P 524447

**ON-SITE SEWAGE DISPOSAL SYSTEM  
HOWARD COUNTY HEALTH DEPARTMENT  
BUREAU OF ENVIRONMENTAL HEALTH**

SUBDIVISION: Cattail Creek LOT NUMBER: 28

ADDRESS: 3625 Sycamore Valley Run PROPERTY OWNER: \_\_\_\_\_

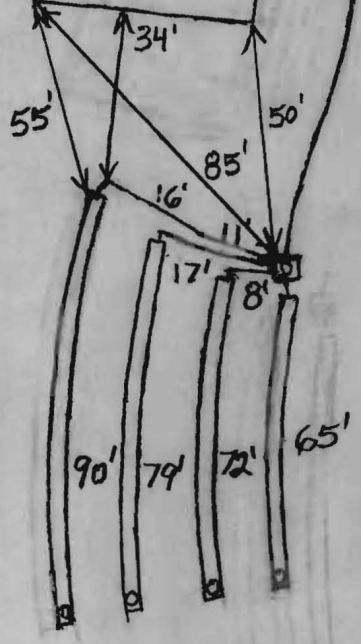
4/12/2012 Install a 60', 70', 80' and 90' trench on contour between the graveyard and the rear property line. Stay away from failed pipe, test holes. Use jointless HDPE pipe for the pump line if less than 50' from the well. Install a 1500 gallon traffic bearing pump chamber to make system compatible for 5 bedrooms. (BB)

4/25/2012 Alarm working. New tank set. Pump line dug. Top two trenches done. (BB)

4/26/2012 System finished. Pump working. (BB)
